APPLICATION NO.	FILING DATE	FIRST NAMED INVENTOR	ATTORNEY DOCKET NO.	CONFIRMATION NO.
10/562,572	12/27/2005	Takashi Isobe	1163-0542PUS1	7881
	7590 02/12/200 ART KOLASCH & BI	EXAMINER		
PO BOX 747	CH 3/A 22040 0747	STERLING, AMY JO		
FALLS CHURCH, VA 22040-0747		ART UNIT	PAPER NUMBER	
			3632	
			NOTIFICATION DATE	DELIVERY MODE
			02/12/2008	ELECTRONIC

This is the **Final Office Action** for application number 10/562,5721 ON-VEHICLE DISPLAY DEVICE, filed on 12/27/05. Claims 20-50 are pending. This **Final Office Action** is in response to applicant's reply dated 12/20/07. The text of those sections of Title 35, U.S. Code not included in this action can be found in a prior Office action.

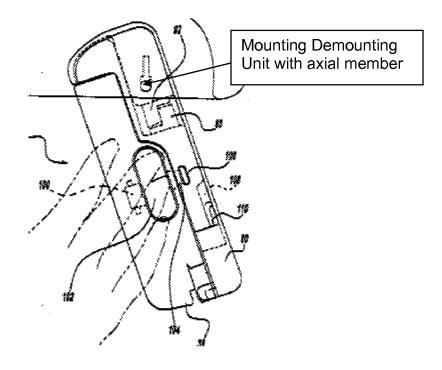
cabinet must be combined with the supporting base in order to mount the apparatus to a surface, enabling determination of a rotational attitude of one of them with respect to the other one for each of a plurality of positions; a mounting and demounting mechanical unit (See Below) for combining the cabinet (38) and the supporting base so that the cabinet can be mounted to and demounted from the supporting base the mechanical unit having an operating mechanical unit for holding or cancelling the combination of the cabinet and the supporting base and wherein an axial member means (See Below) is disposed and used as an axis of rotation, as the mounting and demounting mechanical unit, in one of the cabinet and the supporting base and a convex portion (102) with rotational symmetry is formed, as the attitude setting mechanical unit, in an outer surface of this axial member disposed in the cabinet and an operation means for causing the axial member means to reciprocate is also, as the operating mechanical unit, disposed in the cabinet, and the fitting hole means is disposed in the supporting base and a concave portion (106) with rotational symmetry which is engaged with the convex portion is formed, as the attitude setting mechanical unit, in an inner surface of the fitting hole means.

the base and mounting bracket affixed by different methods (64 and 62), fitting holes (See Figure above for holes) on opposite outward facing ends of the base such the holes are disposed along a straight line wherein the apertures and floors of a pair of holes lie along the same straight line, the holes having such a shape that a display may be slidably inserted and retracted from fitting holes wherein a socket portion of the fitting hole is disposed within the base such that the socket portion rotates with respect to the base.

The applicant has argued that the Sanders et al reference does not teach an axial member disposed in the cabinet. The definition of the cabinet has been changed to 38, (See rejection above), the axial members being shown in the marked figure above, thereby meeting this limitation.
